City of Lewisville, TX Agenda

Joint Meeting of the Planning and Zoning Commission, Overlay District Board, and Transportation Board

Tuesday July 7, 2020

TO: Planning and Zoning Commission
FROM: Jon Beckham, Senior Planner
DATE: July 7, 2020
SUBJECT: **Final Plat of Trinity Townhomes Addition Lots 1-8, Block A; on 0.302 Acres out of the A.G. King Survey, Abstract Number 698; Zoned Old Town Mixed Use 2 (OTMU2) District; Located on the Northwest Corner of Main Street and Leonard Street.**

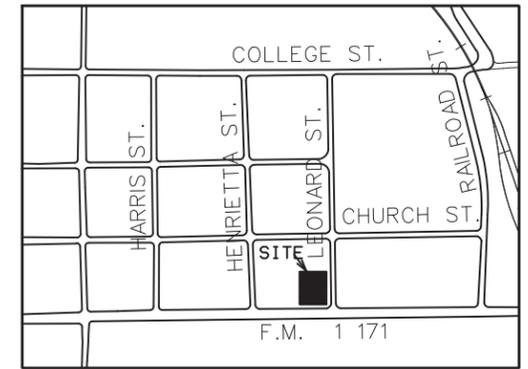
YOUNG JUN SUNG
STATE OF TEXAS
COUNTY OF DALLAS
This does not match the county record. Please update to match current owner (John D Lim) or provide deed.

Please correct

Add the following language: Filed: _____ DOC.# _____, P.R.D.C.T.

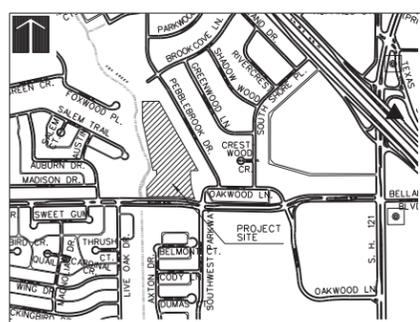
Need a current title opinion as Row is being dedicate per Sec's 6-27 and 6-28.

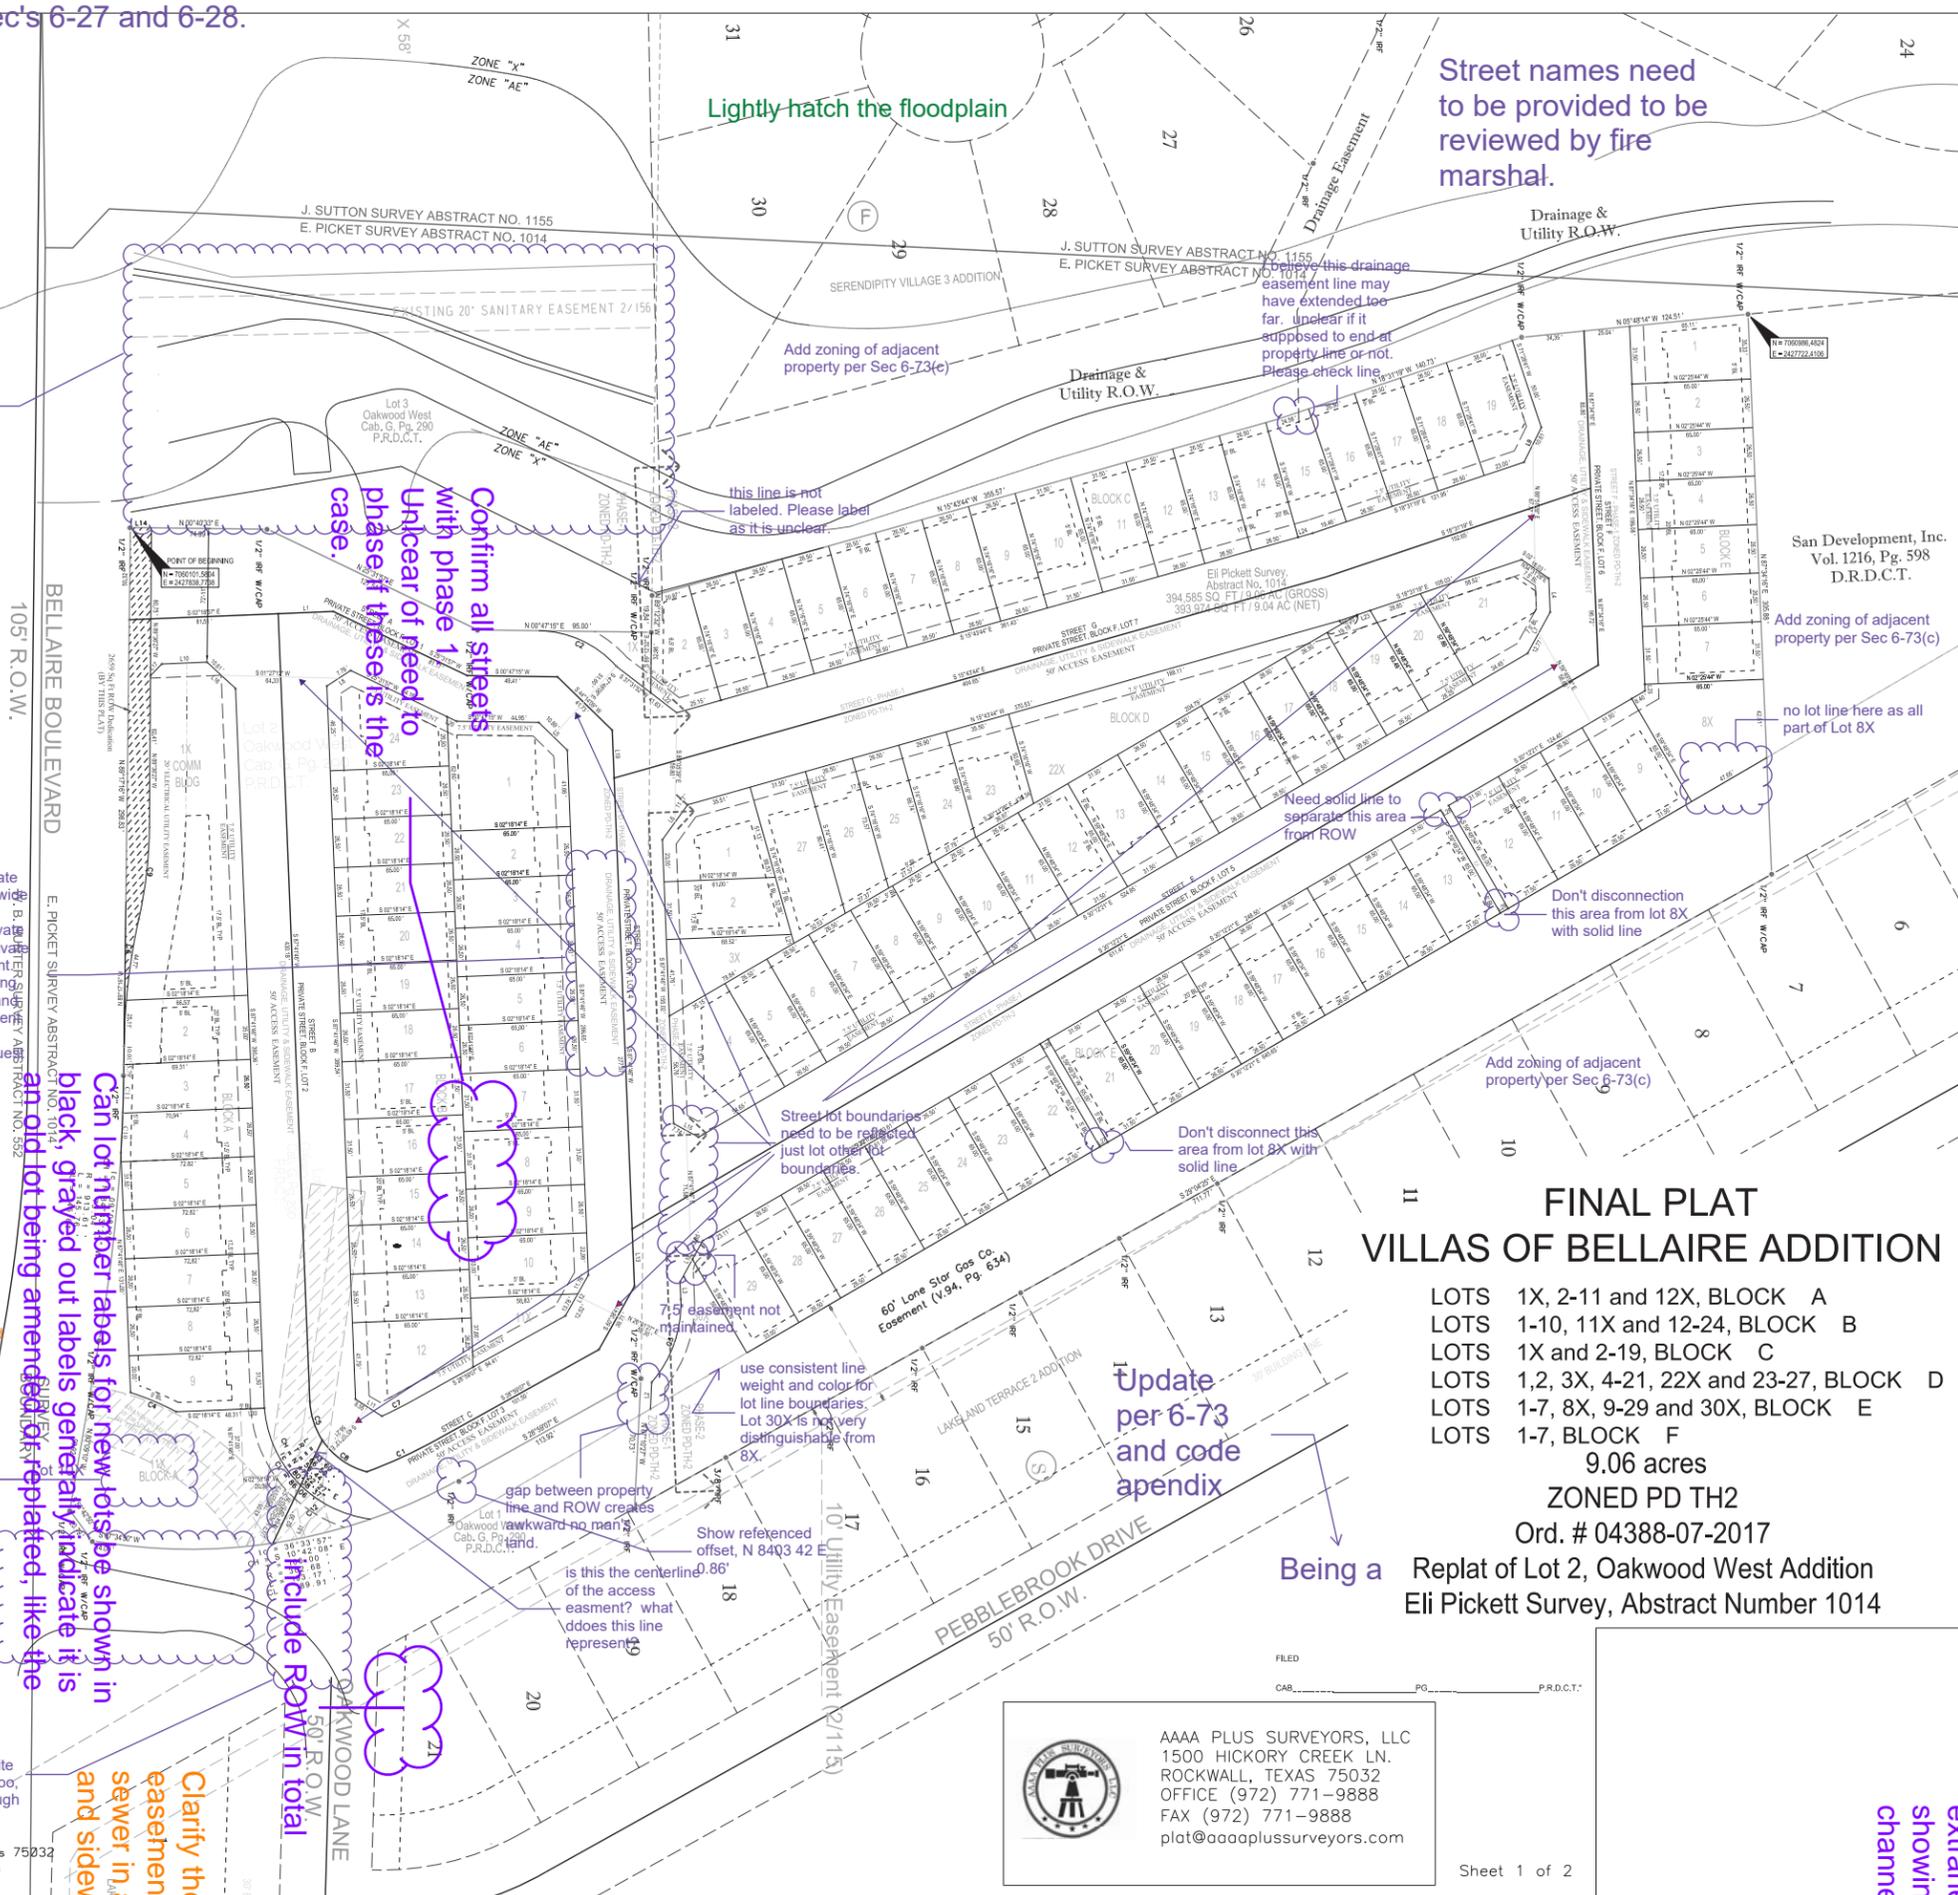
Can lot number labels for new lots be shown in black, grayed out labels generally indicate it is an old lot being amended or replatted, like the drainage easements you show in grey.

Clarify the public utility easement includes water and sewer in addition to drainage and sidewalk.

remove lines showing existing improvements like pavement, show ROW, property lines, easements, etc.

Show off-site easement or fire access. Show on site access easement too, appears to go through

Street names need to be provided to be reviewed by fire marshal.

Don't show any pavement boundaries or physical improvements on plat. Remove extraneous lines, showing drainage channel pavement.

Add zoning of adjacent property per Sec 6-73(e)
